Enclosure 3
January 2009 Meeting Handouts
Meeting Summary of the 01/14/09 Reactor Oversight
Process Working Group Public Meeting
Dated February 24, 2009

Accounting for Post Maintenance Test Failures in the Mitigating Systems Performance Index

Staff White Paper on NEI 99-02 Guidance Changes for MSPI for Clarification of
Planned UA Expectations (Industry proposed revision)

FAQ – Dedicated Operators Draft Rev. 10 01/06/09

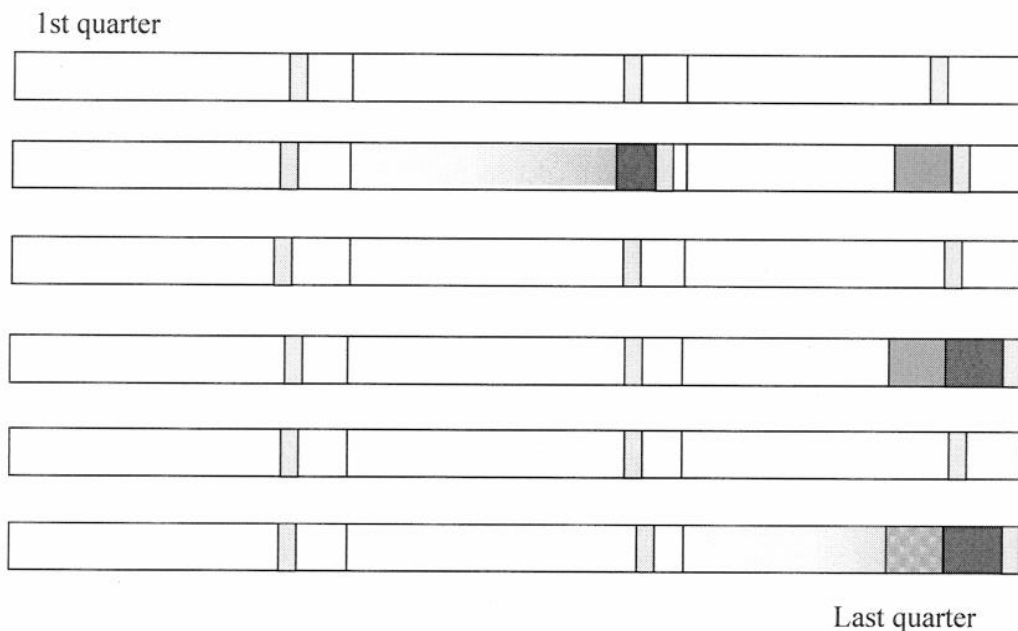
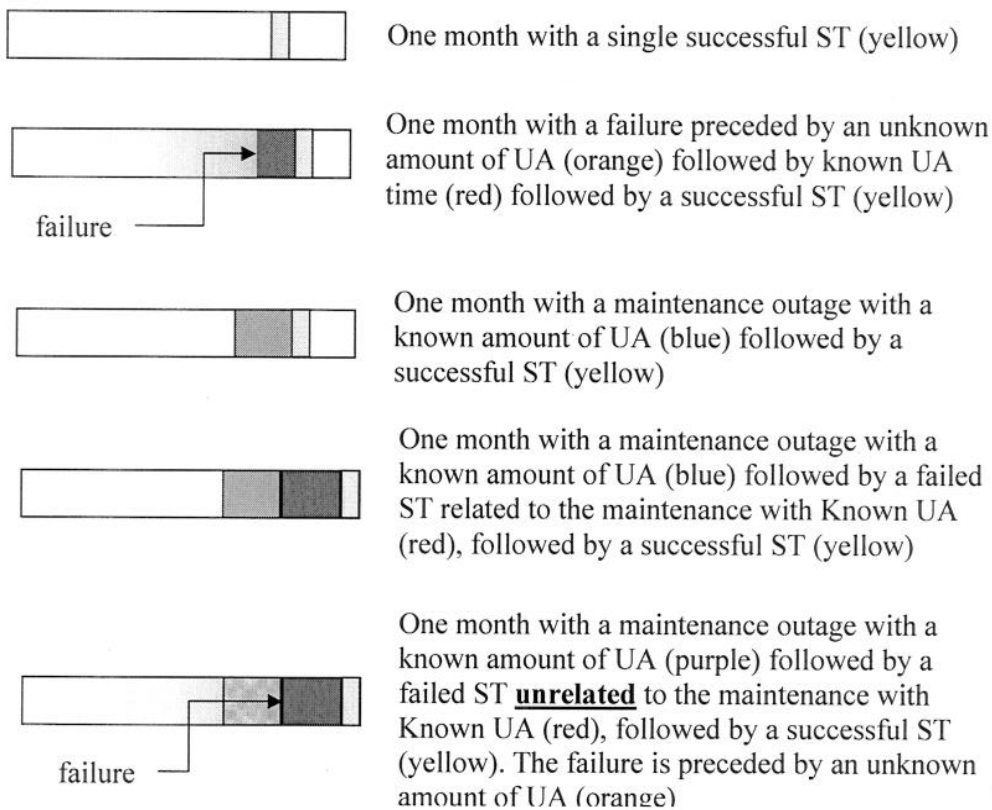
Consider 6 quarters of operating history for an EDG that are depicted in the following figure. Each rectangle represents one month of operating history. This constructed operating history can be used to test different interpretations of the guidance to see which one results in the correct answer because the correct answer is known explicitly from the constructed history.

The key to the diagram is provided in the figure below, but in summary the history includes 18 months of history. In the 18 months there is one ST each month depicted by the yellow

block. The ST does not affect the availability of the DG and for illustration purposes should be considered a perfect ST in that it can identify all possible failure modes of the EDG.

There are three planned maintenance events in the history (blue and purple blocks) each lasting 48 hours. There are three unplanned maintenance events (red blocks) following failures of the EDG, each one assumed to last 24 hours. In two of the failures, there was a period when the EDG was in an undetected failed state (orange shaded block) prior to the failure. Because we use demand related failure rates in MSPI as opposed to a failure rate with a test interval exposure time, the time the EDG is assumed to be in an undetected failed state is the entire 30 day interval since the last successful ST. In the case of the second of the three failures on the chart, it was determined that the failure event was caused by the maintenance activity prior to the failure and the EDG was not in an undetected failed state prior to the planned maintenance.

This answer is close to the previous answer, but not identical because this method does not adequately account for the overlap of planned unavailable hours and hours in an undiscovered failed state in the last month. We could account for this by subtracting the 48 planned hours from the numerator of the second term in the equation above and the results would be identical.

Counting the failure that occurred post maintenance in the 12th quarter as an MSPI failure would significantly overestimate the probability as given by:

We conclude that to get the correct answer from the MSPI method, only two failures should be counted, even though it is known that there were three failures in the 18 month period. To decide if the failure should be counted or not it is important to remember that the Un-Reliability term is included to estimate the number of hours that a component was thought to be functional, but was actually in an undiscovered failed state.
